No. 1158
ATA Code 25-00

SUBJECT: EQUIPMENT/FURNISHINGS - INSPECTION AND POSSIBLE REWORK OF LAP BELT AND SHOULDER HARNESS ASSEMBLIES MANUFACTURED BY AMERICAN SAFETY EQUIPMENT CORPORATION

Service Instructions No. 1158

Figure 1

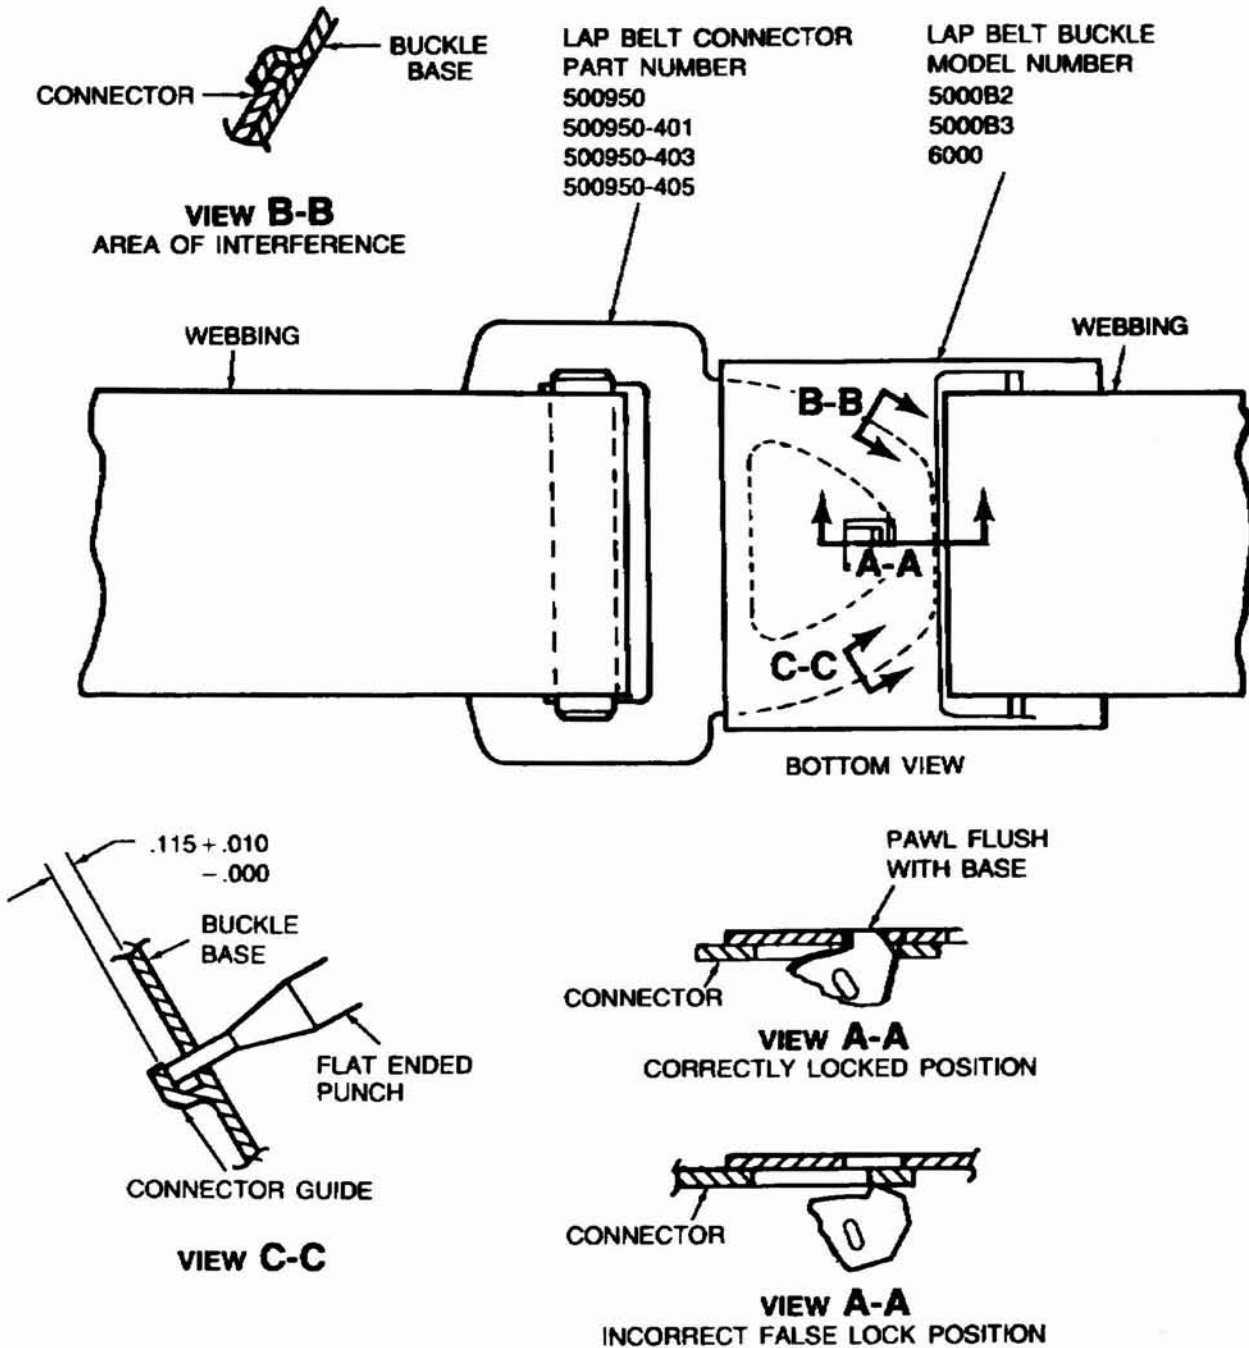
1. Inspect all lap belts in the airplane to determine if the buckles and connectors were manufactured by American Safety Equipment Corporation and have one of the part/model numbers shown in Figure 1. American Safety Equipment Corporation buckles have the words "American Safety" and the model number stamped on the back of the buckle.

3. If the lap belt buckles were manufactured by American Safety Equipment Corporation and have one of the model numbers shown in Figure 1, proceed as follows:

- a. Remove the connector from the buckle.
- b. Inspect the connector guides on the buckle and determine if the clearance between the guide and the buckle base is $.115 + .010 - .000$ inch as shown in Figure 1, View C-C.
- c. If the connector guides on the buckle have the correct clearance, no further action is necessary.
- d. If the connector guides on the buckle do not have the correct clearance, use a flat punch as shown in Figure 1, View C-C and rework the guides as required to obtain the proper clearance.
- e. Check the lap belt assembly for proper operation as shown in Figure 1, View A-A.

Figure 2

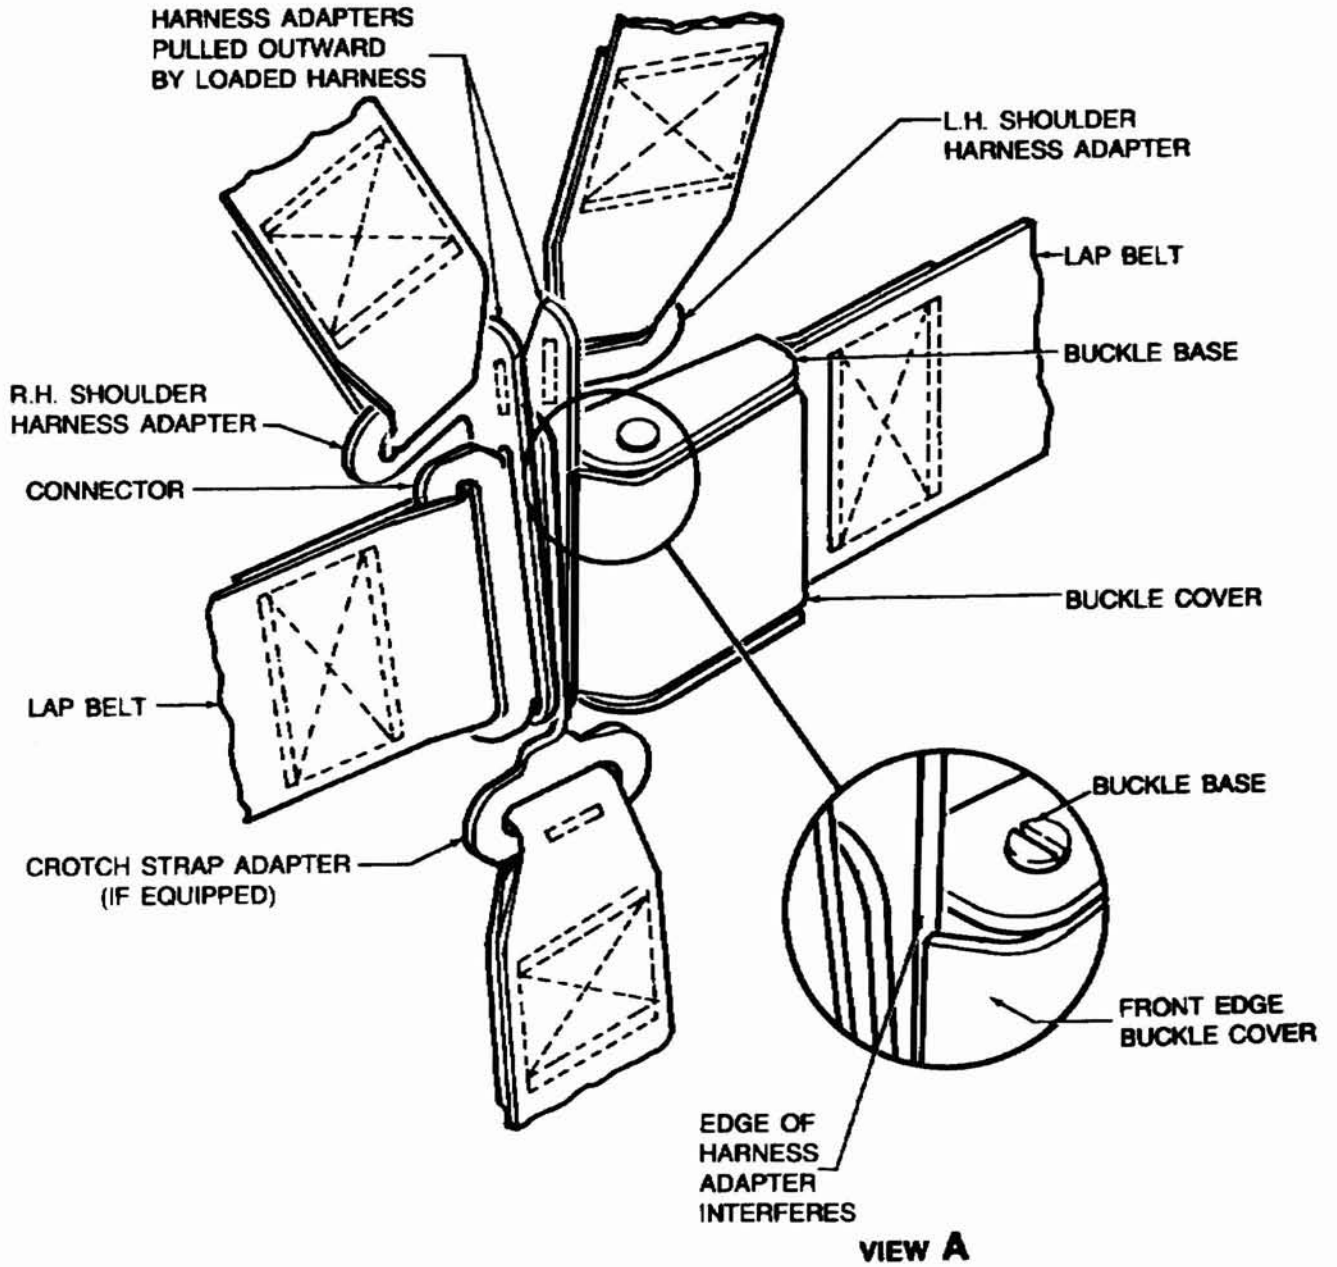
1. Inspect the lap belt buckles on all seats which have shoulder harness and/or crotch strap adapters that slide over the connector as shown in Figure 2 and determine if the buckles were manufactured by American Safety Equipment Corporation or Cummings and Sander. American Safety Equipment Corporation and Cummings and Sander buckles will have the words "American Safety" or "Cummings and Sander" stamped on the back of the buckle.

Figure 3

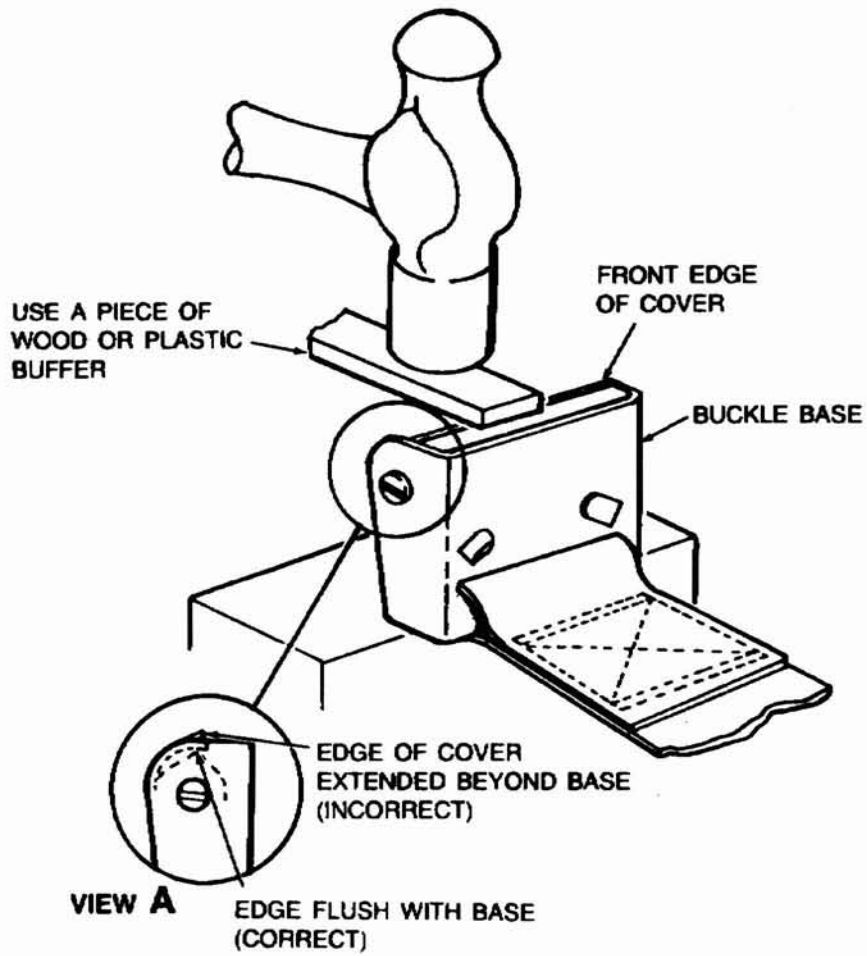
- a. Inspect the lap belt buckle cover for proper contour and interference with the shoulder harness and/or crotch strap adapters as shown in Figure 2 and Figure 3. The contour of the cover should follow the curved front edge of the buckle base as shown in Figure 3, View A.
- b. If the buckle cover has the correct contour and does not interfere with the adapters, no further action is necessary.
- c. If the buckle cover does not have the proper contour, set the back edge of the buckle base on a firm support and tap the front edge of the cover with a hammer as shown in Figure 3. Use a wood or plastic buffer between the hammer and the cover to reduce the possibility of damage to the cover as shown in Figure 3.
- d. Check the lap belt and shoulder harness assembly for proper operation and to assure that no interference exists between the cover and the adapters.
